Pre-bid MOM: Open tender for Supply of 2X630 kVA Dry Type Horizontal Oriented Distribution Transformer
Ref. Tender No.AEML/MDB/2021-22/27 Dated : 21/05/2021

2X630KVA CRT

Annexure 1

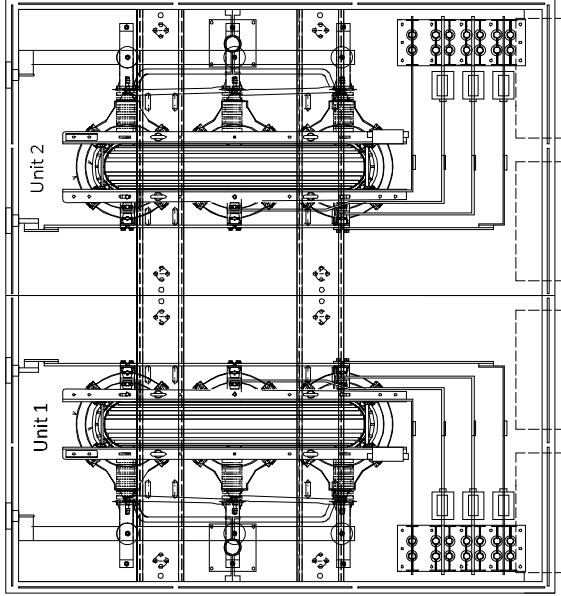
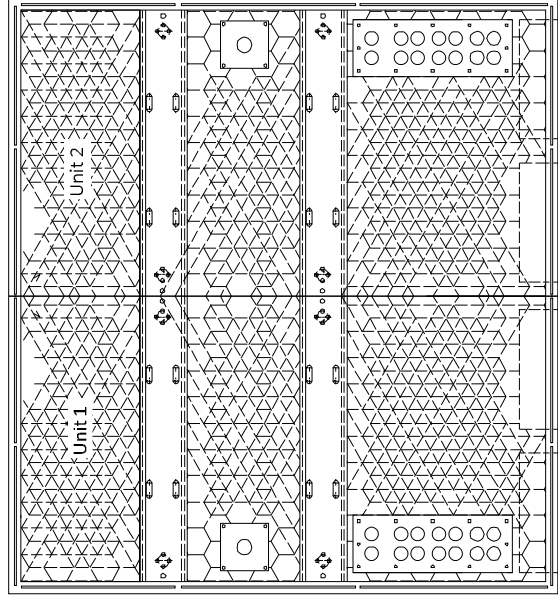
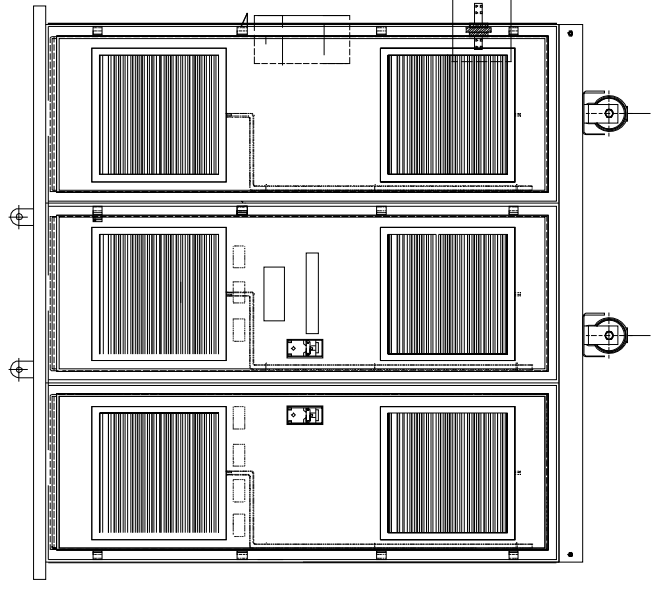
Sr. No.	Document Name	Document No.	Vendor Query/ Point of discussion	Corrigendum / AEML Clarification
1	Specifications of 2X630 kVA Dry Type Horizontal Oriented Distribution Transformer	Specification No : SP-CES-EL-DRDTR-03	Where the two transformers are getting connected at LV and HV side?	Both the transformers shall be fed from separate HV SWITCHGEAR and shall be connected to separate LV switchgears. HV/LV switchgears in AEML scope. Provision of LV load shifting arrangement from one transformer to another shall be made within LV switchgear panel by AEML.
2			Scope of vendor	Scope of Vendor: - 1) Design, manufacture and supply 2X630kVA Dry DTs, placed in horizontal orientation in single enclosure. 2) Supervision of OEM engineer for ITC of transformers: – 2 nos. of man-days per transformer.
3			Orientation of CCAs for unit 1 and 2 in enclosure.	The attached concept GA drawing of 2X630 KVA is for reference only. CCA Orientation for making units identical or stability of complete unit etc. is OEMs perview. Only three side access shall be available during operation of 2X630 KVA , therefore there shall be no accessories mounted on non accessible side. GA drawing attached in MOM as Annexure 1.
